**RE: Response to Approval with Modifications
French Drain Soil Sampling Investigation Work Plan
Western Refining Southwest LLC, Marathon Gallup Refinery
EPA ID# NMD000333211
HWB-WRG-20-022**

ATTACHMENT A – RESPONSE TO COMMENTS

New Mexico Environment Department (NMED) to Marathon Petroleum Company (MPC) Comment Letter “Approval with Modifications French Drain Soil Sampling Investigation Work Plan” (January 8, 2021)

MARATHON PETROLEUM CORPORATION
GALLUP REFINING DIVISION
FRENCH DRAIN SOIL SAMPLING INVESTIGATION
WORK PLAN

| | SITEWIDE LIF SAMPLE LOCATIONS | | | |

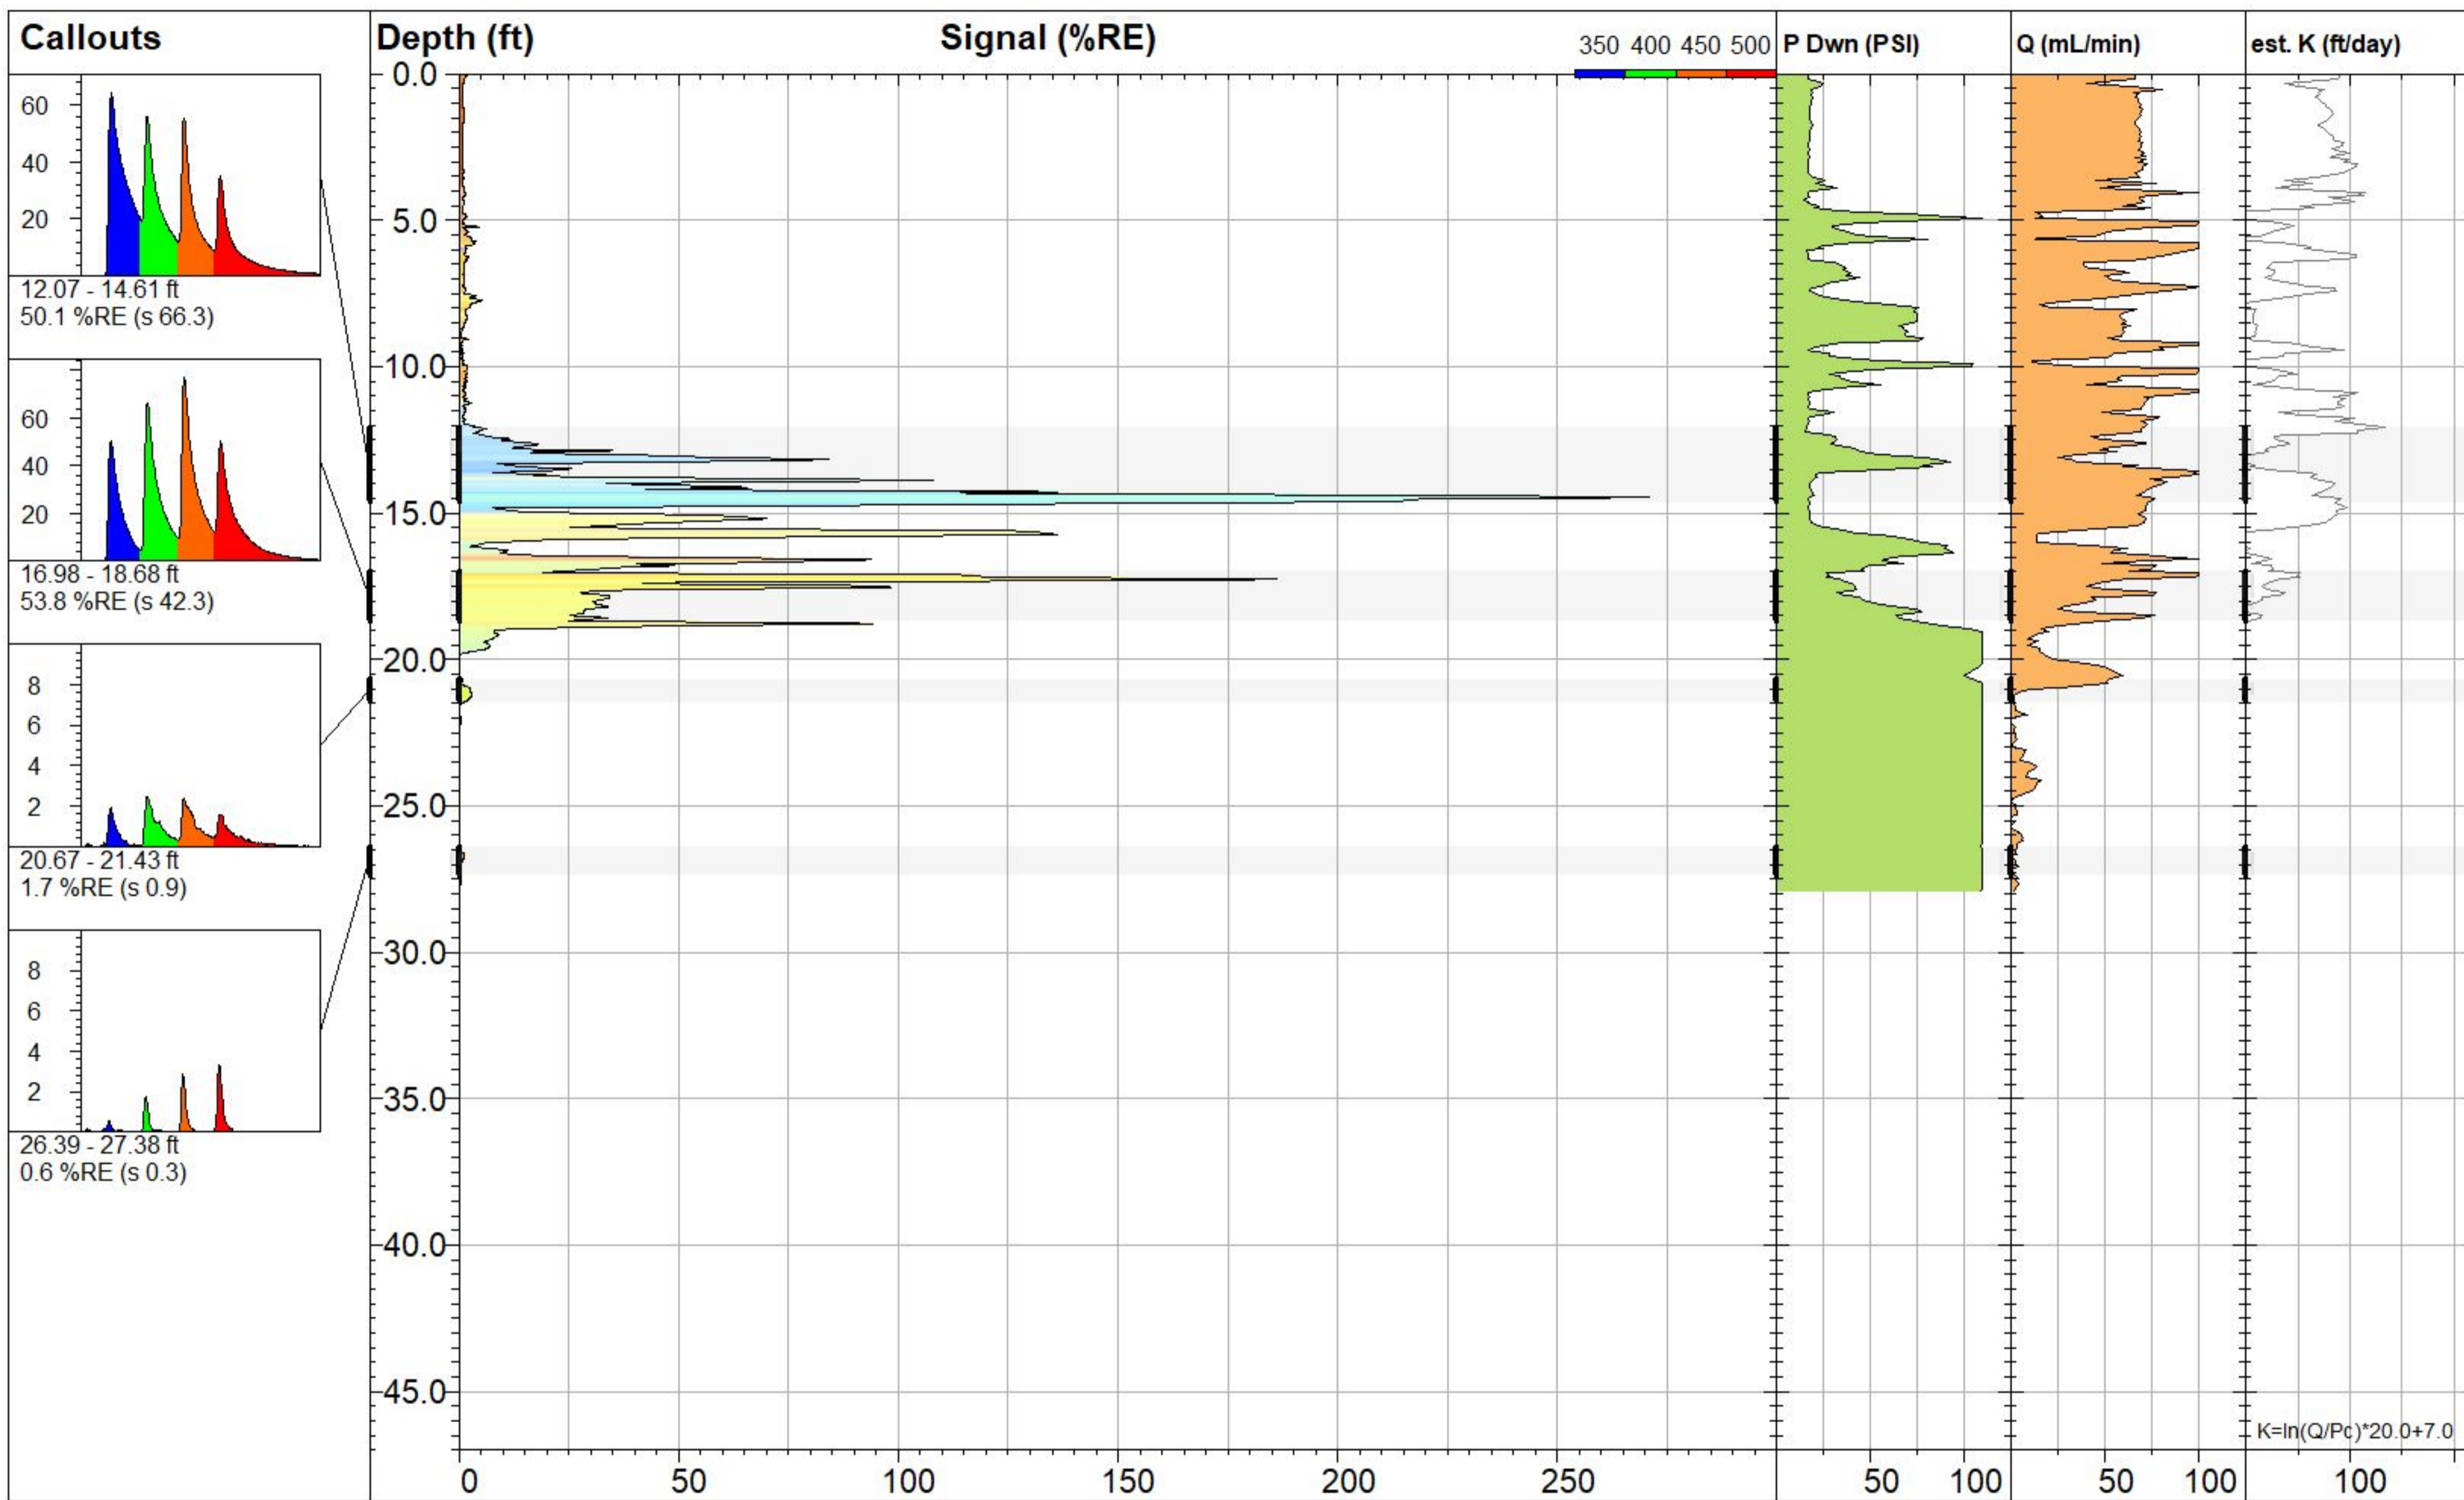
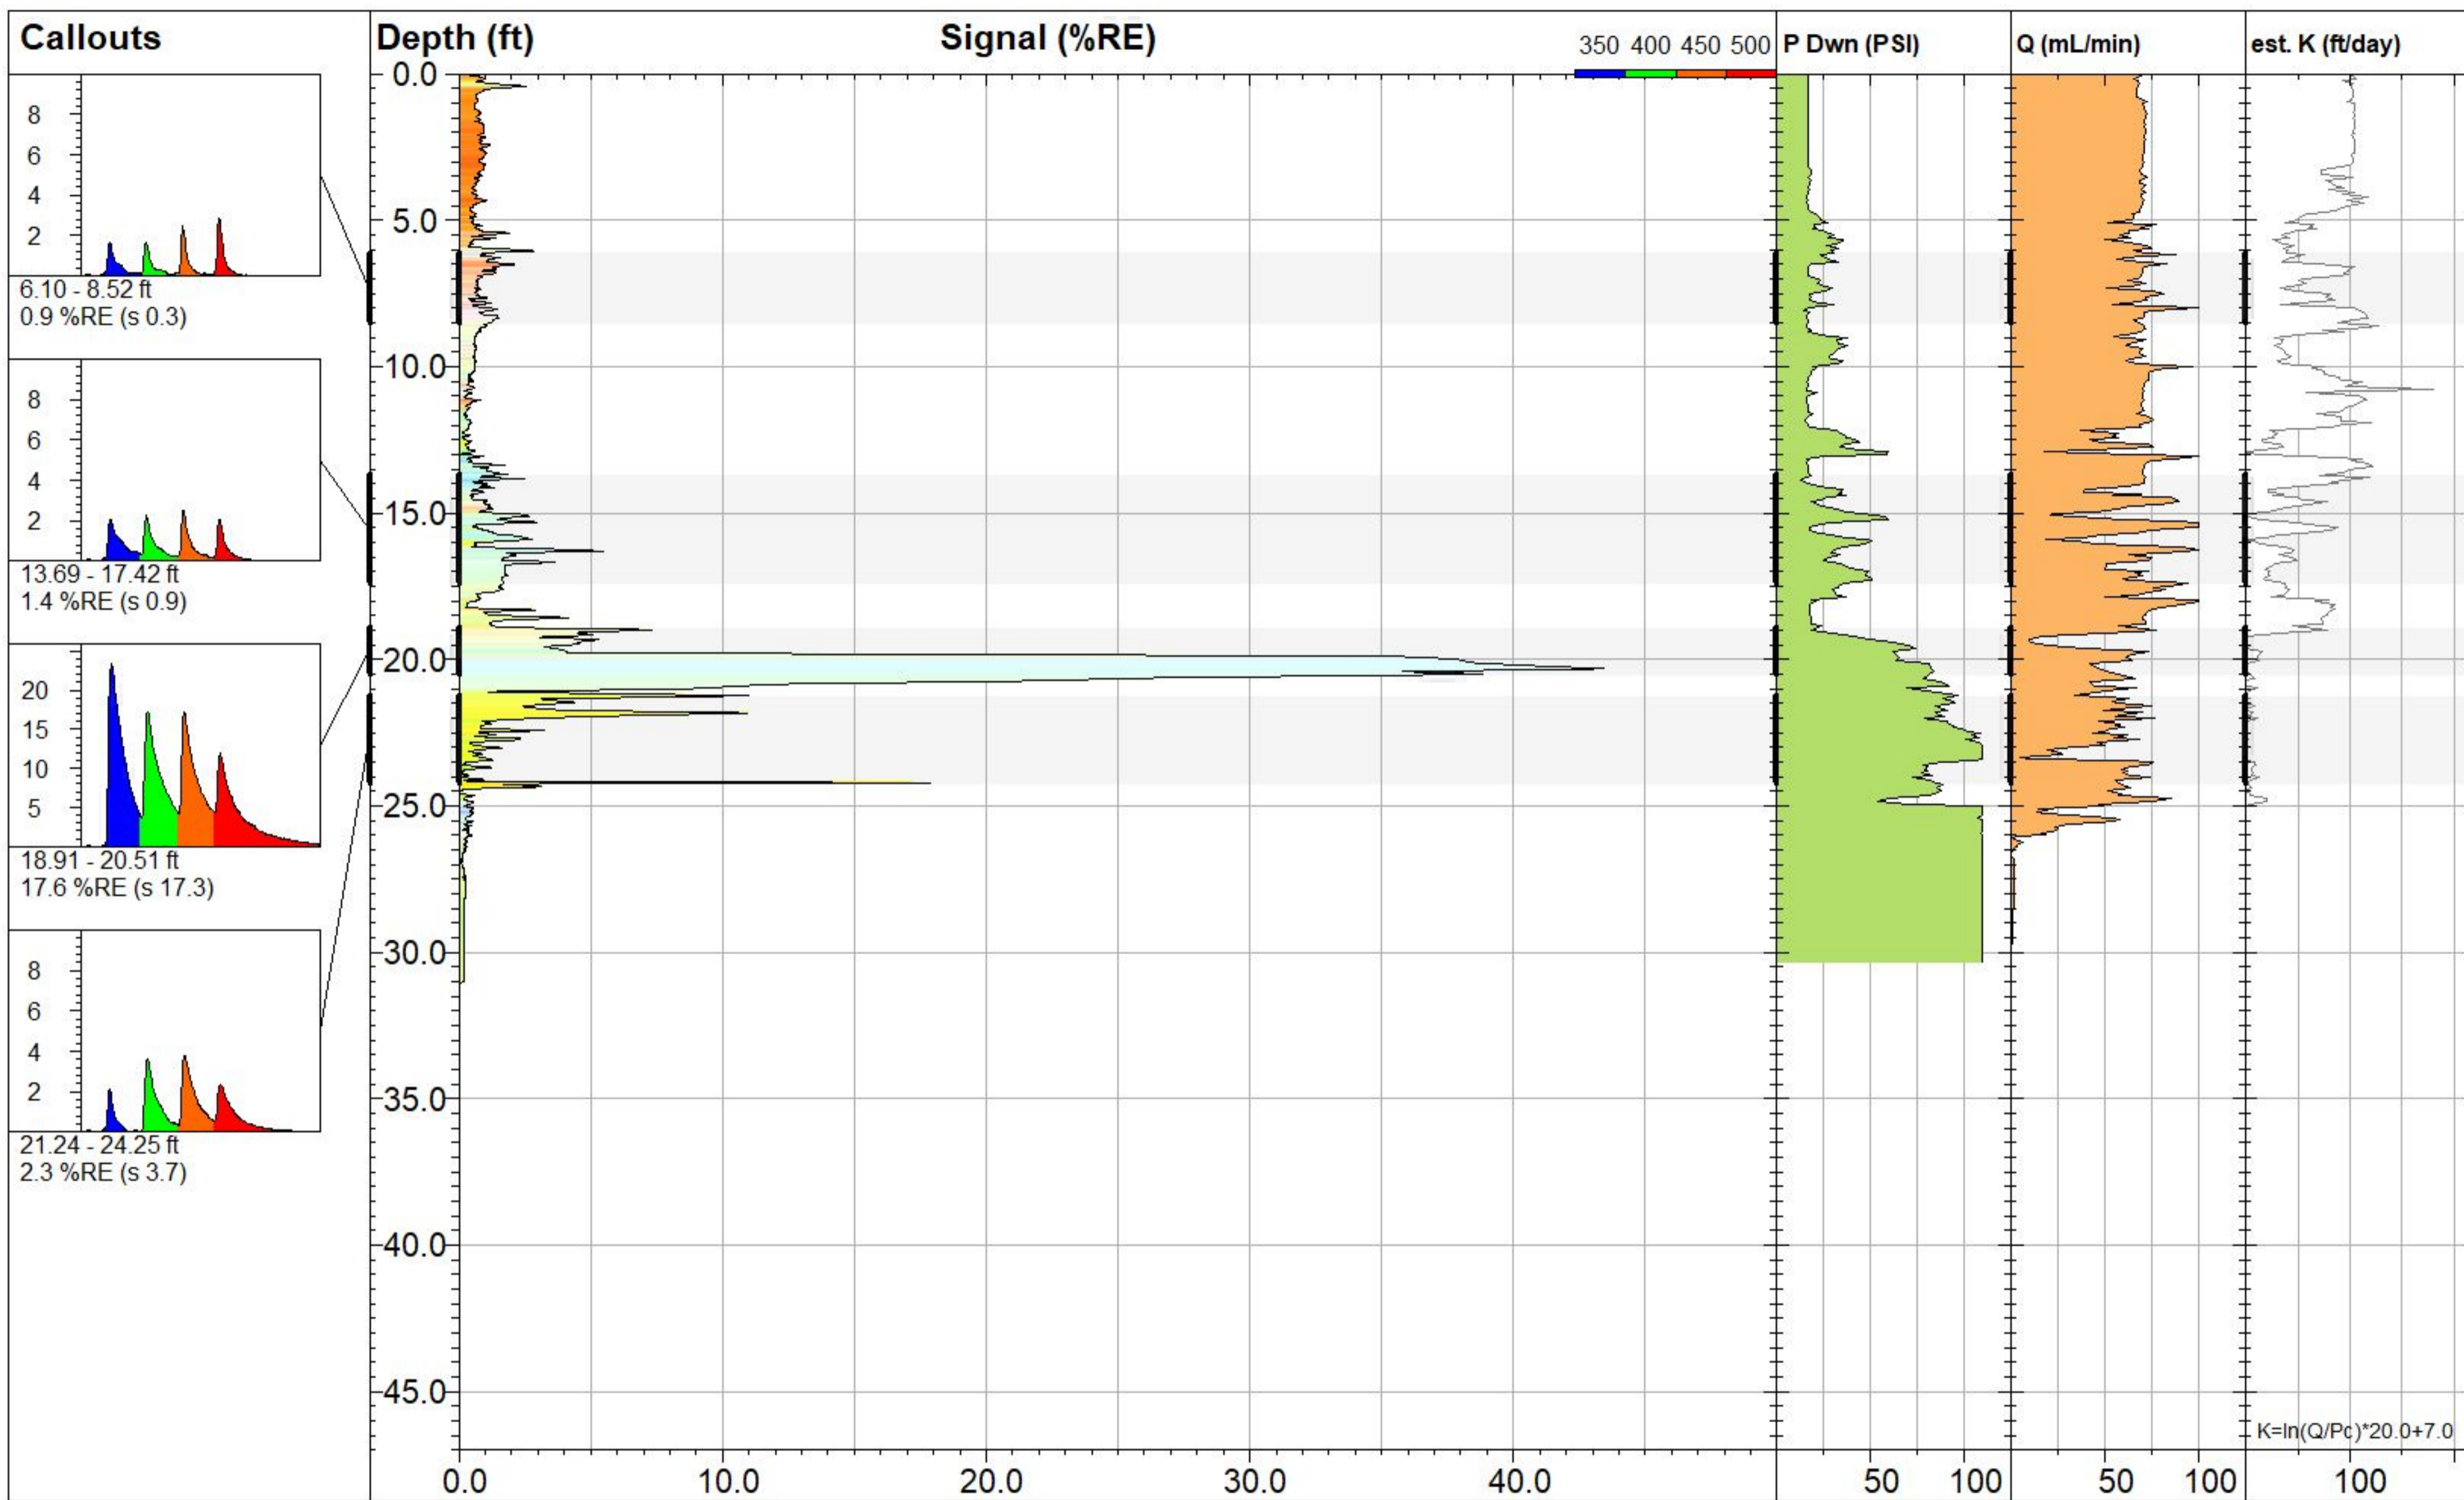
| NMED Comment | MPC Response |
|--|--|
| <p>Appendix A, <i>Well Logs</i>, does not include a boring log for SB-FD-1. In addition, Figure 3 does not depict any proposed borings north of STP-1 to investigate presence or absence of contamination associated with the French Drain release. Provide a boring log for SB-FD-1 and discuss whether (1) hydrocarbons were detected at location SB-FD-1 and (2) soil investigation is warranted north of STP-1 in the response letter.</p> | <p>2018 the drilling rig was set up on location SB-FD-1. Sample collection was accomplished using the HSA drilling method and split spoon samplers. No discrete soil samples were retained for laboratory analysis since the field screening results did not indicate potential contamination and the focus of this effort was the identification of SPH. The lithology encountered consisted of the following:</p> <ul style="list-style-type: none"> ▪ The 0 to 10 foot interval was not logged due to use of hydro excavation to clear the location; ▪ Silty Clay: 10 - 14 feet below ground level (bgl) (low plasticity, very stiff, dry to damp, reddish brown, calcareous at base no odor); ▪ Silty Clay: 14 - 24 feet bgl (low plasticity, firm/crumblly, damp, light reddish brown, very calcareous 15.75 — 16.0 feet, no odor, increase in silt lower 2 feet); ▪ Silty Clay: 24 - 38 feet bgl (low plasticity, very stiff, dry to damp, reddish brown with greenish gray color from 24 to 26 feet bgl, thin 1” sandstone lens at 25.75 feet and calcareous 34 to 36 feet bgl, no odor); <p>The boring was left open for two days but did not produce water and was plugged on March 9, 2018.”</p> <p>Figure 3, <i>Proposed Soil Boring Location</i>, does not depict any proposed soil borings north of STP-1 because the area was included in Sitewide LIF Investigation, completed during the week of May 10, 2021. The Sitewide LIF location figure is provided in Attachment C.</p> |

| NMED Comment | MPC Response |
|---|--|
| <p>Comment 7:</p> <p>In the Investigation Methods Section, page 7, the Permittee states, “[t]he proposed sampling locations are shown on Figure 3. The proposed locations include six boreholes around the STP-1 French Drain area.” The proposed sampling locations shown on Figure 3 are anticipated to delineate the extent of hydrocarbon contamination detected at BH-1, BH-2, and Excavation #9; however, do not appear adequate to delineate the extent of hydrocarbon contamination detected at BH-3 and potential hydrocarbon contamination northwest of the French Drain. Two additional soil borings as shown in the figure below must be proposed in the revised Work Plan. The suggested boring locations below may be adjusted based on the accessibility of the site. Revise the figure accordingly.</p> <p><u>[Suggested additional boring locations were provided by NMED on a figure included with the comment.]</u></p> | <p>Response 7:</p> <p>Figure 3, <i>Proposed Soil Boring Location</i>, does not depict any proposed soil borings in the vicinity of BH-3 and potential impacts north west of the French Drain because the area was included in Sitewide LIF Investigation, completed during the week of May 10, 2021. The Sitewide LIF location figure is provided in Attachment C. The Sitewide LIF investigation provided adequate coverage of the area</p> |
